Plan Holders of: **GRETCHEN TALLEY PARK – PHASE III IMPROVEMENTS
1551 DOVE DRIVE, TRACY, CA – CIP NO. 78170**

Subject: Addendum No. 2

ADDENDUM NO. 2

FD-3

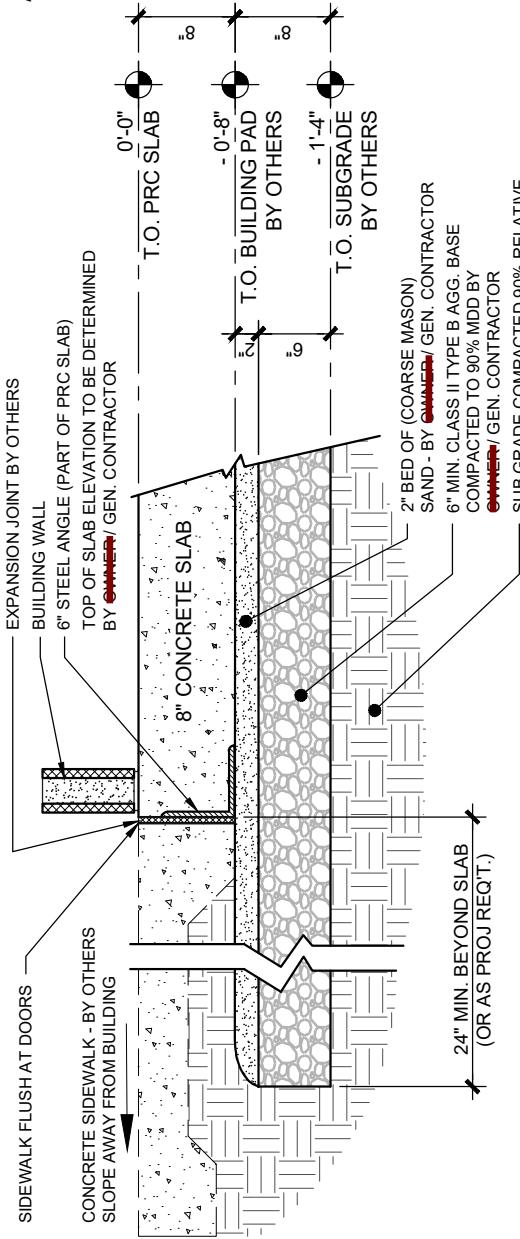
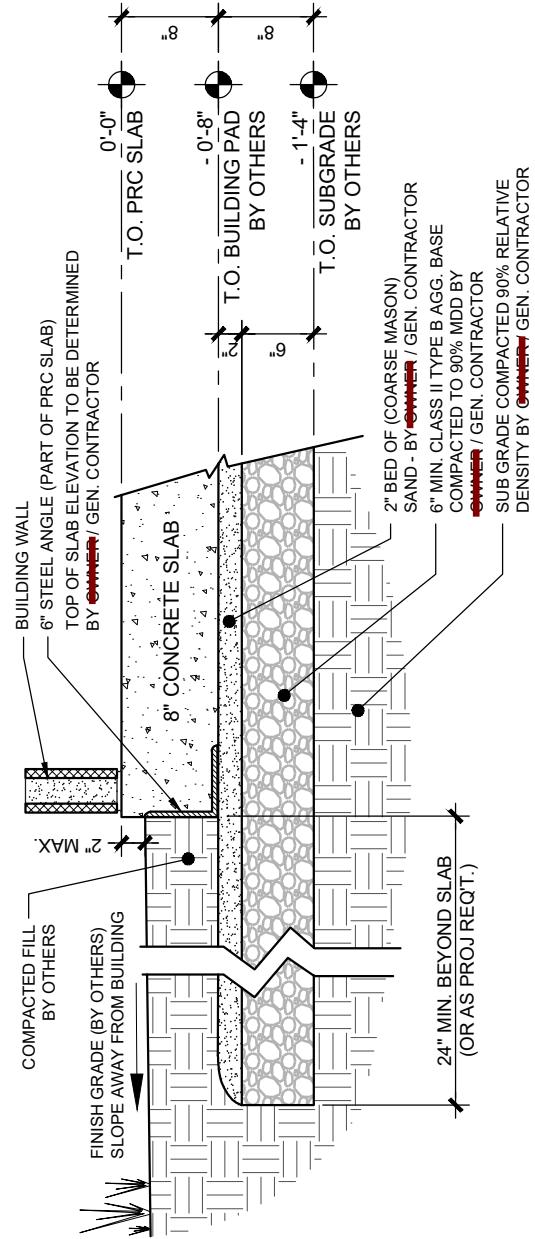
13. *QUESTION: Plans – Sheet L7.11 – Construction Details - The detail FD-2 'Example Pad Preparation Plan' needs more clarification. There are no materials called out nor are there any depths given for them Please provide a more detailed drawing with materials and dimensions for the base under the Restroom Bldg.*

ANSWER: The detail is for reference only. Detailed restroom drawings are a deferred submittal by City, per deferred submittal list on cover sheet. For bidding purposes the Contractor shall use attached Detail 1 and 2 on Sheet FD-3 (Attachment 2). All work/materials shall be provided by Contractor with exception of the premanufactured building with 8" slab attached. See Section 6 of the Geotechnical requirements for additional requirements.

SHEET
L2.0

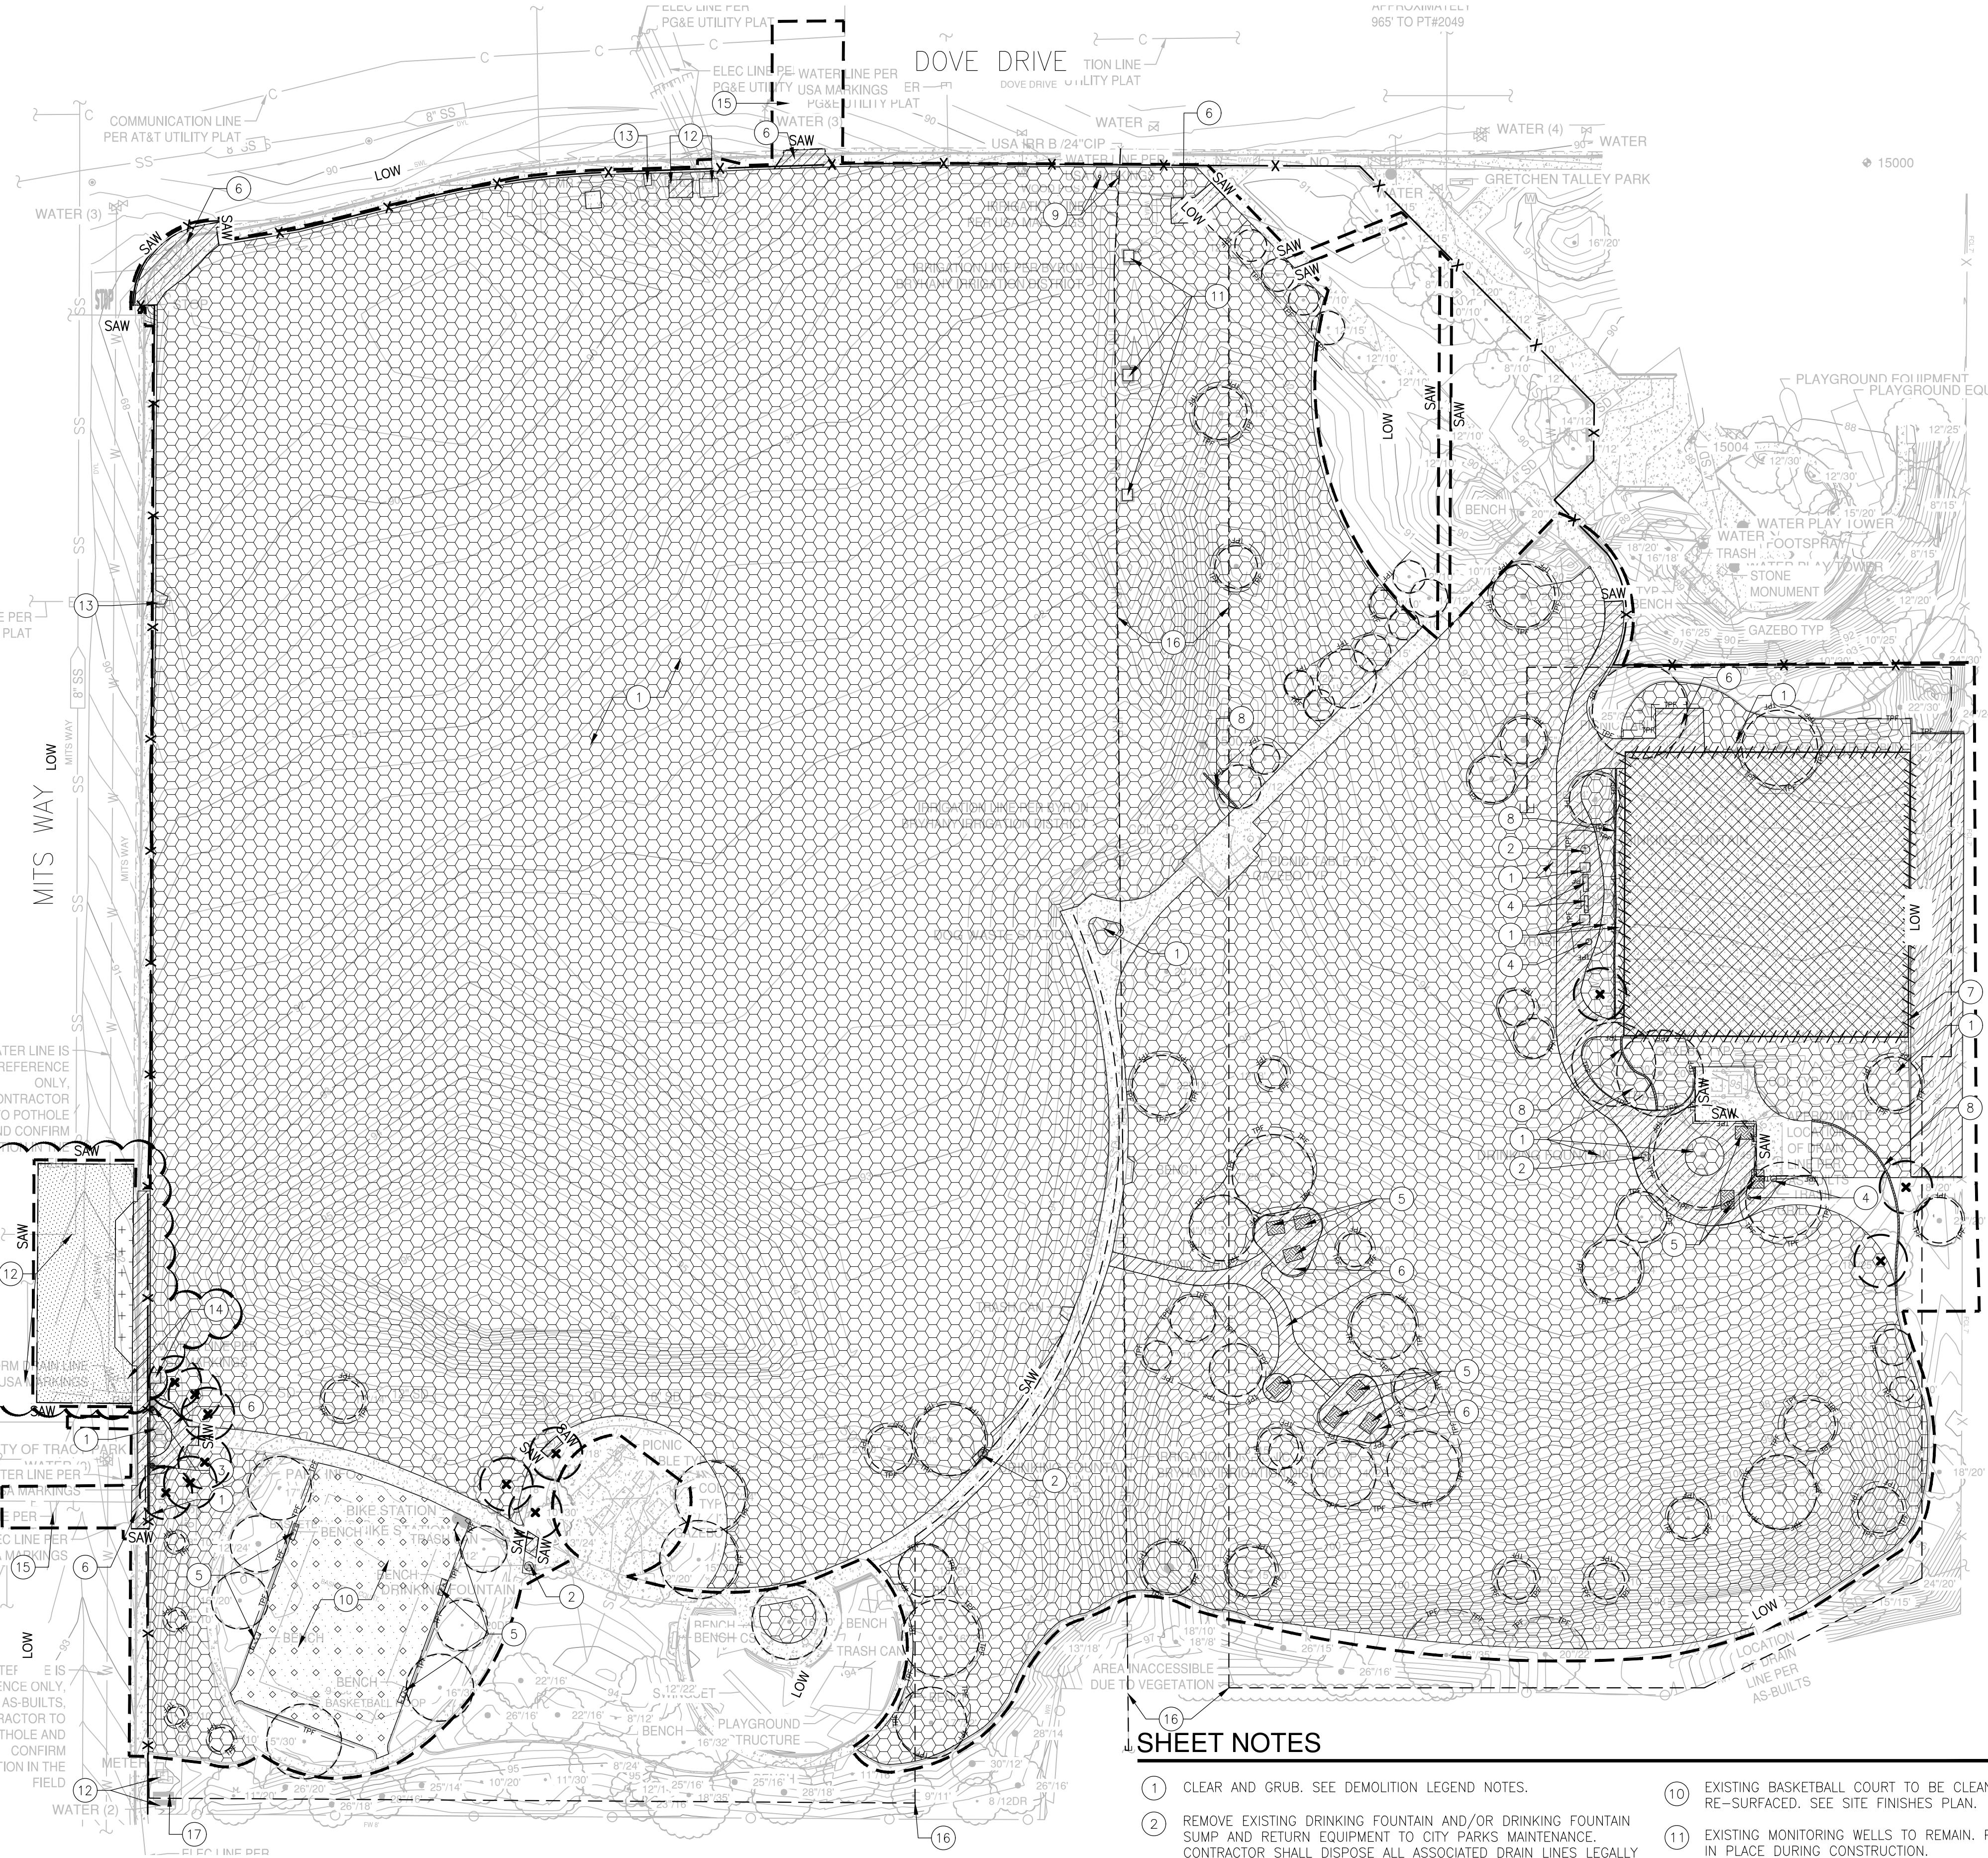
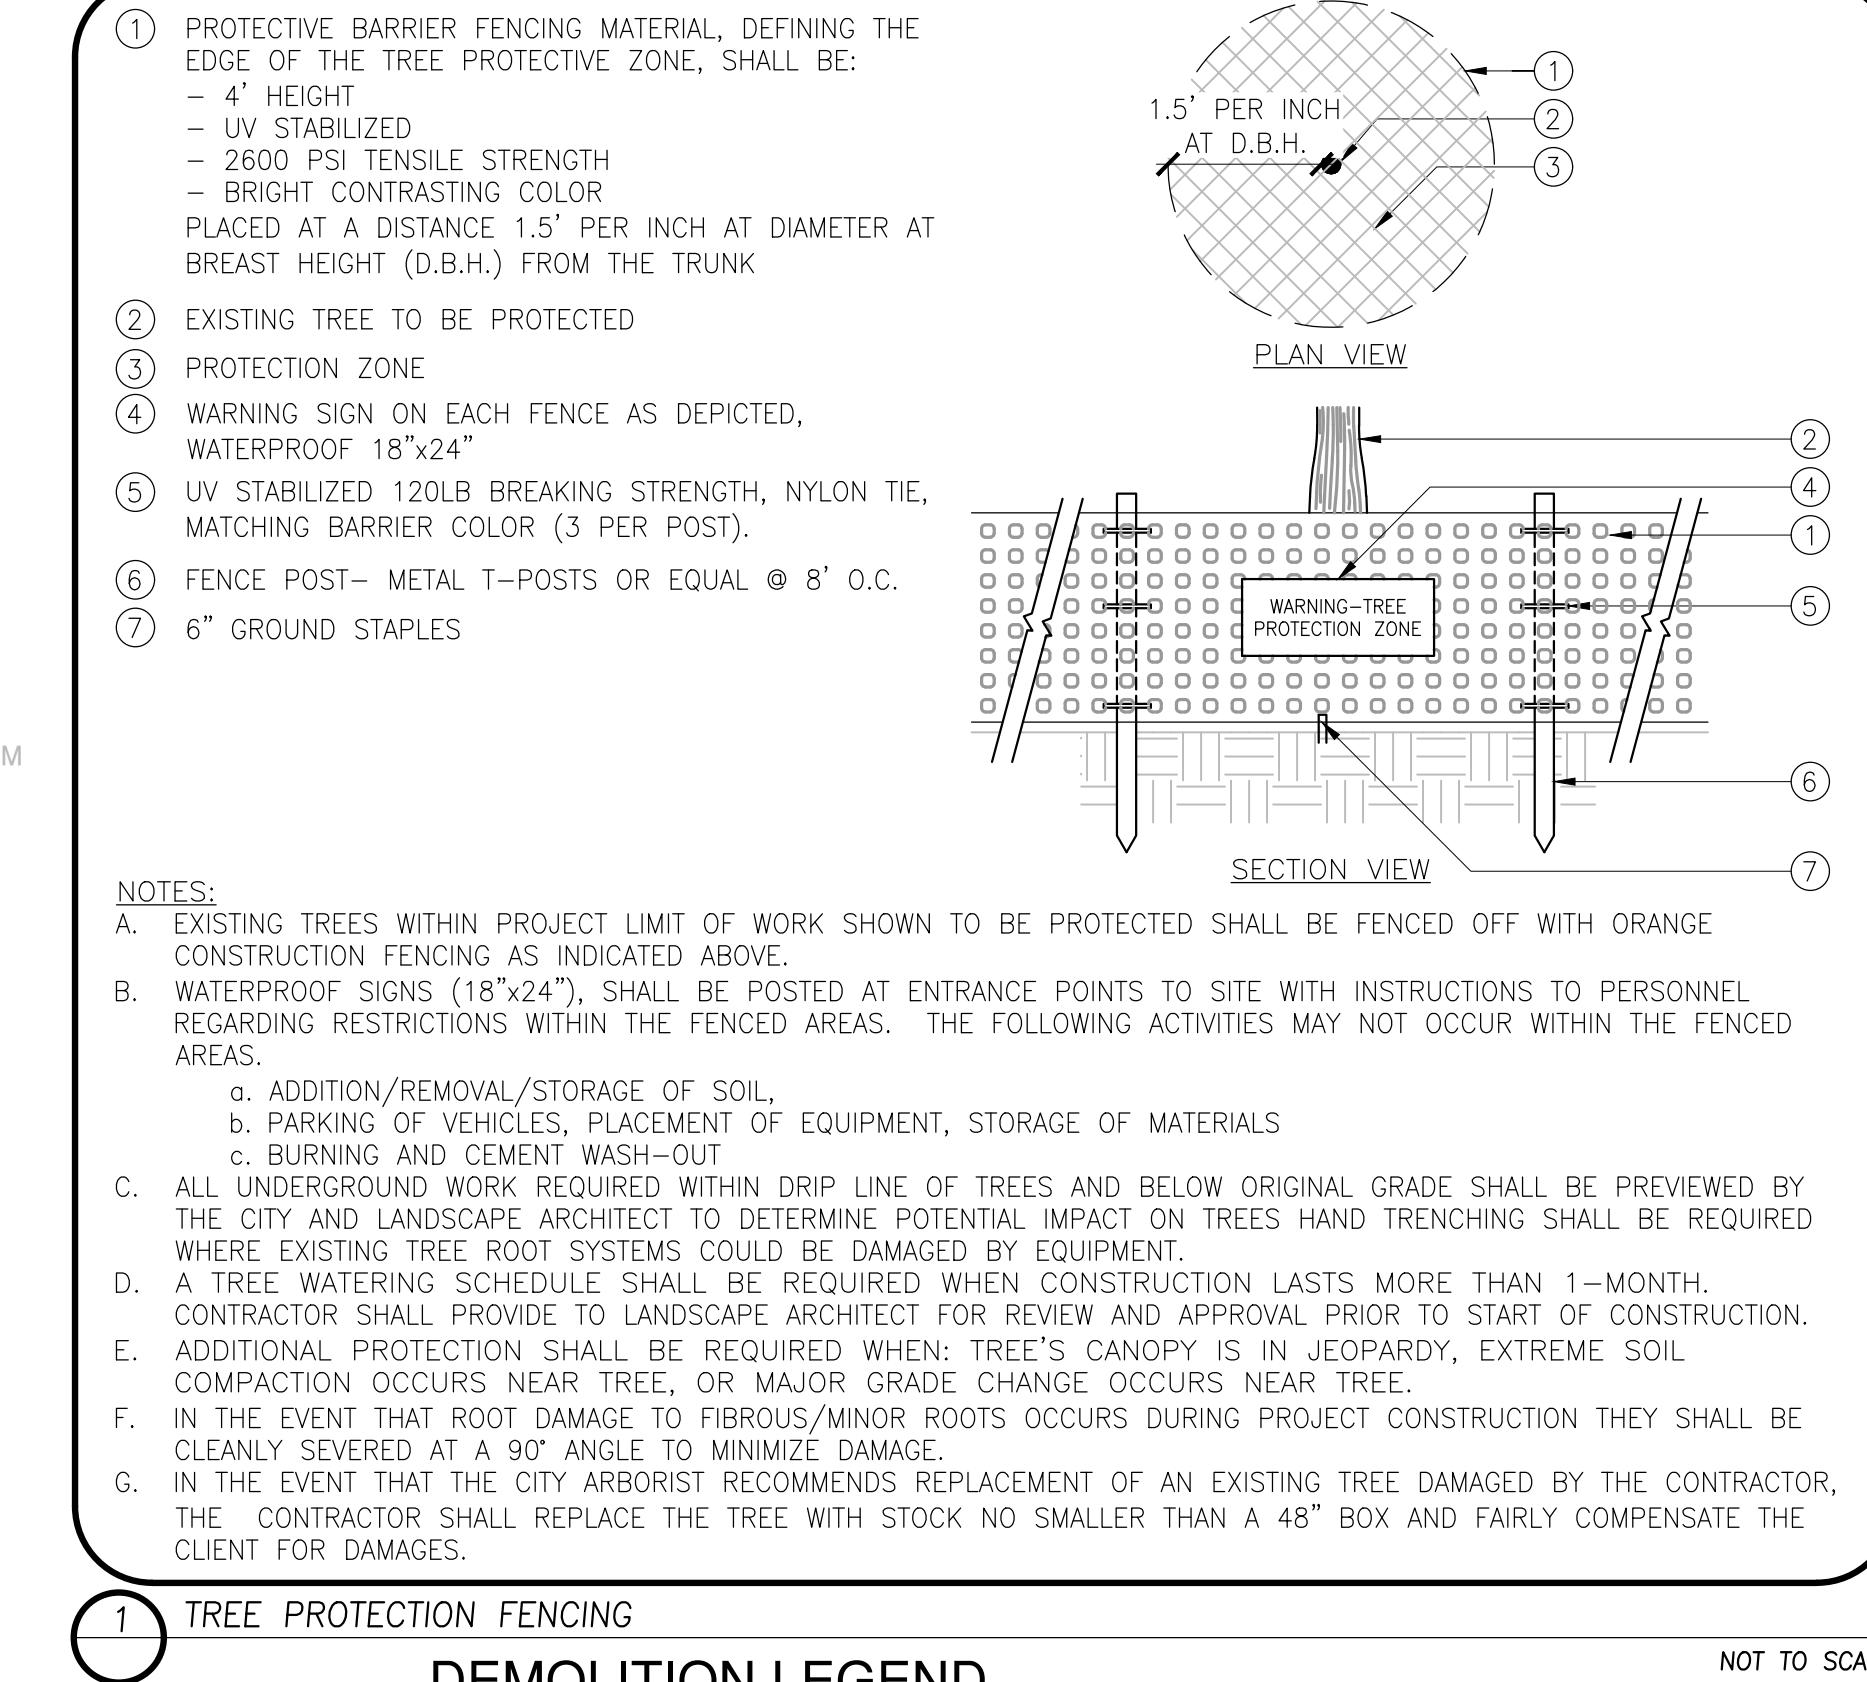
Item No. 1	L2.0 – Additional sawcut and removal with grinding in specified locations and modifications to demolition legend.
Item No. 2	C1.0 – Revisions to Sewer and Water Pipe Materials.
Item No. 3	C1.1 – Addition of accessible parking zone section, modification of callout on Detail 3.
Item No. 4	C2.0 – Modification to legend.
Item No. 5	C2.1 – Modification of accessible parking and addition of grinding and overlay and modification to legend.
Item No. 6	C2.2 – Addition of cleanout rim elevations and modification to legend
